File PP-1996-077

Name: Hacienda Subdivision – F ¼ / 24 ½ Road

FILE: PP-96-77
DATE: May 29, 1996
STAFF: Kathy Portner
REQUEST: Preliminary Plan--Hacienda
LOCATION: F 1/4 and 24 1/2 Road
APPLICANT: J.B.I. Associates

TITLE HEADING: Preliminary Plan - The Hacienda

DAILY SITE TRAFFIC TRIP ASSIGNMENT

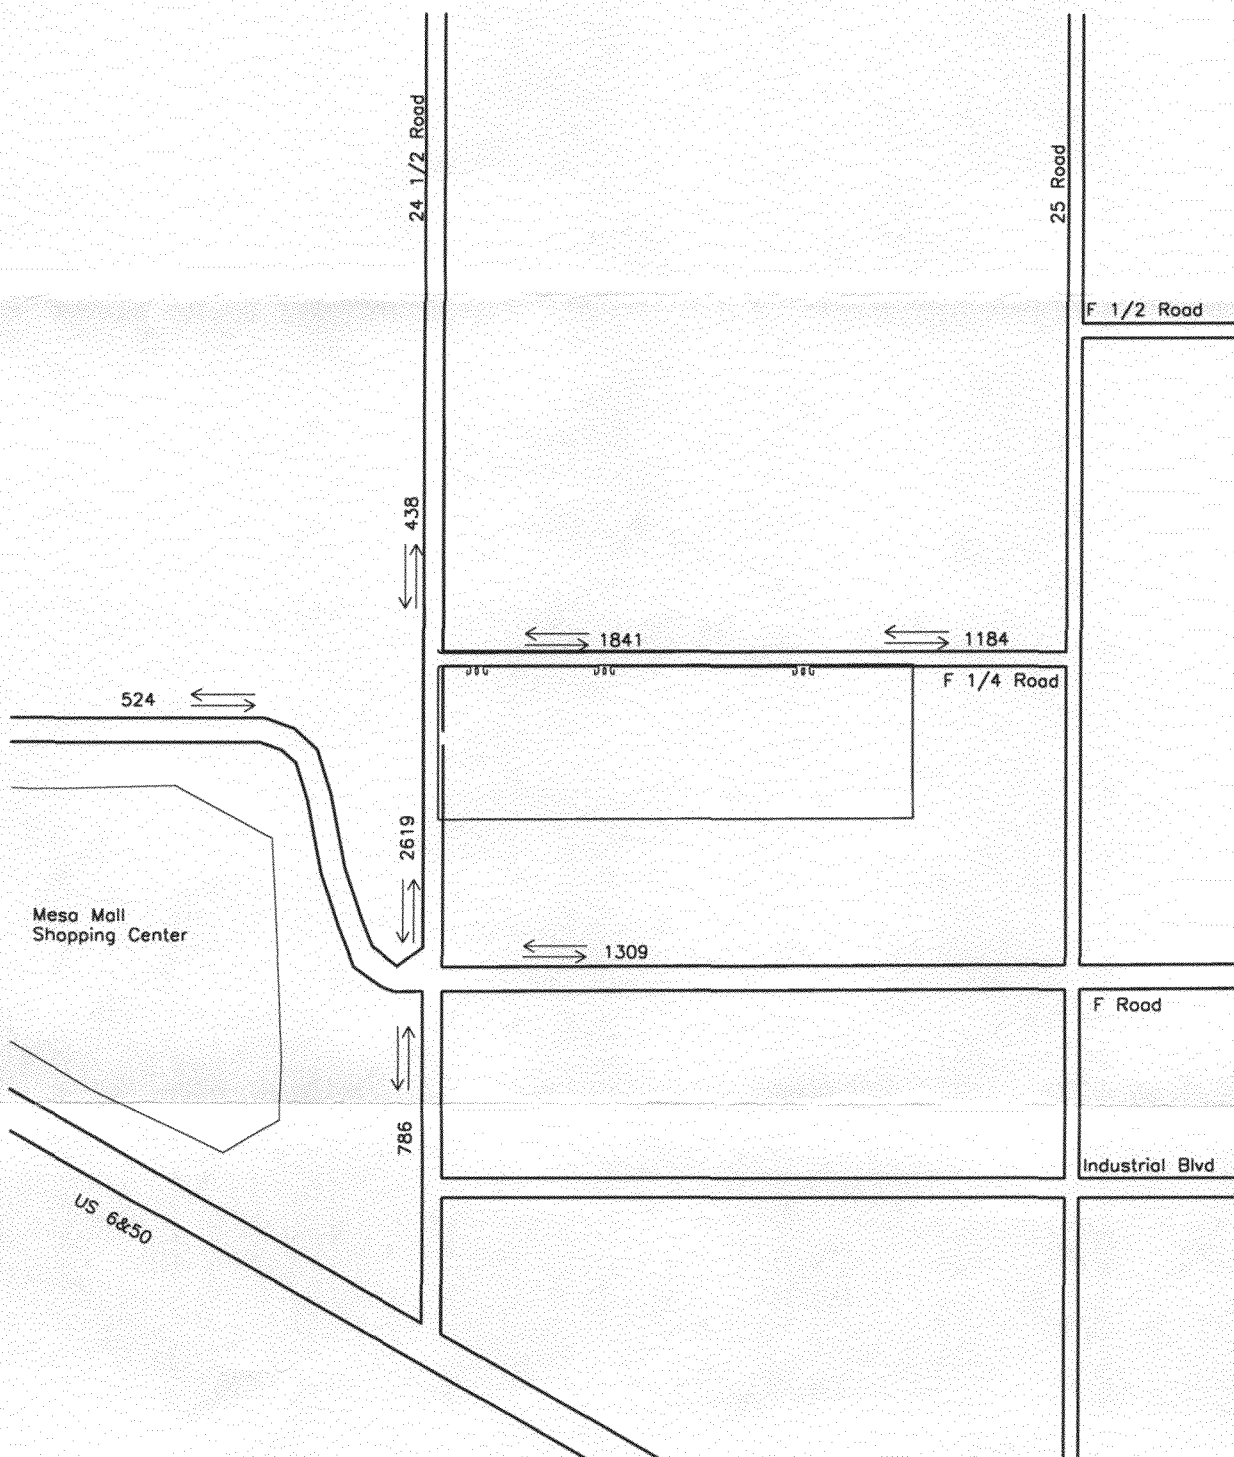
5. On the drawing for am and pm peak hour site traffic, show the distribution at the F 1/4 and 24 1/2 Road intersection. At F and 24 1/2, the trip assignment shows 20% WB and 30% SB, but the distribution assumes equal percentages.
